P38 Jack Placement Study

Review of Jack Dimensions for Tire Replacement

On October 4th, 2021, Honda Engineering received a request to review any issues that may arise from the use of a TRONAIR 02-7813C0100 Jack to replace an Main Landing Gear Tire

Installation of the Jack – Weight ON Wheels

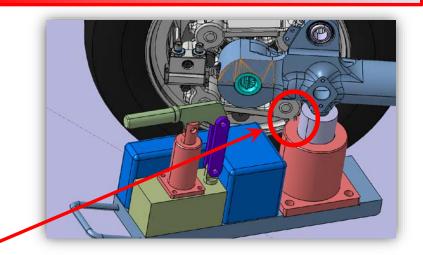
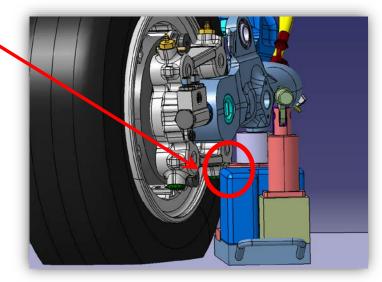
- With the 02-7813C0100 jack, orientation is required to clear the tire.
- Interference is noted between the jack and the brake depending on Aircraft Loading
 - Lighter weight aircraft may have less contact than that shown in these pictures.

Installation of the Jack – Weight OFF Wheels

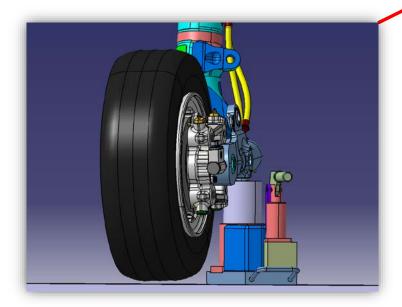
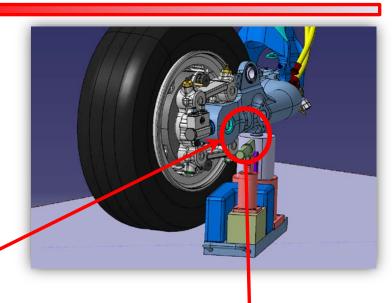
- Interference is noted between the outer jack piston and the brake.
 - Outer piston may have contacted the brake prior to full piston displacement, causing the next concentric piston to extend.
 - May be possible to inspect brake for indication of contact.

Cross Section of Wheel / Brake / Trailing Arm Stack

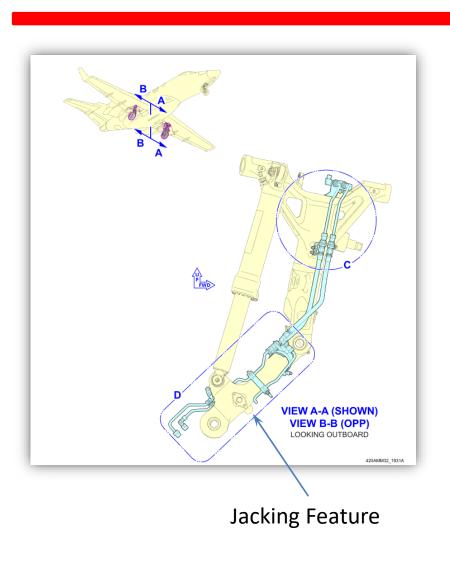
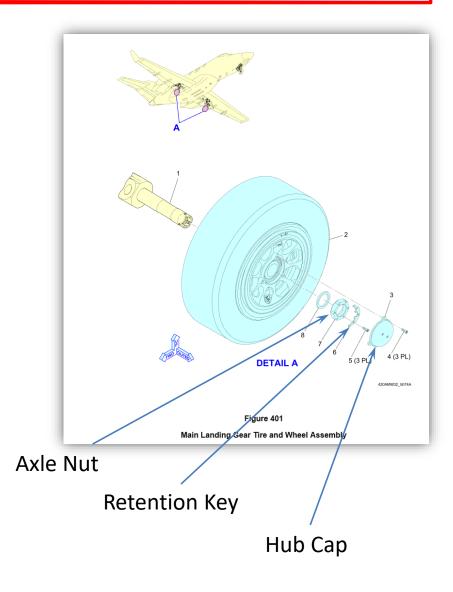
- With the Jack in orientation shown on previous slides, there is potential for it to interfere with the Brake.
 - When the torque is removed from the Axial Nut, contact between the Jack and the Brake would have an tendency to push the Brake OTBD.

- If the Brake has migrated OTBD, when re-installing the Wheel / Tire Assembly, the Wheel / Tire Assembly may be prevented from fully seating. In addition, the Axle Nut may not seat properly and may prevent the Retention Key from engaging the Key Slot on the Axle.

- Torqueing of the Axle Nut would still be possible due to the Nut Torque being reacted by the interference between the Jack and the Brake

Figure 204
MLG Single Point Jacking

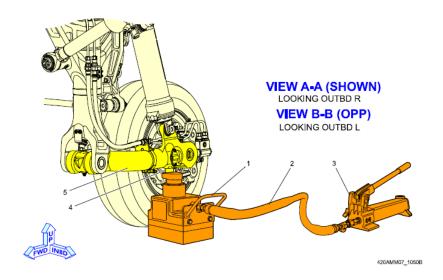
Proper Jack Usage
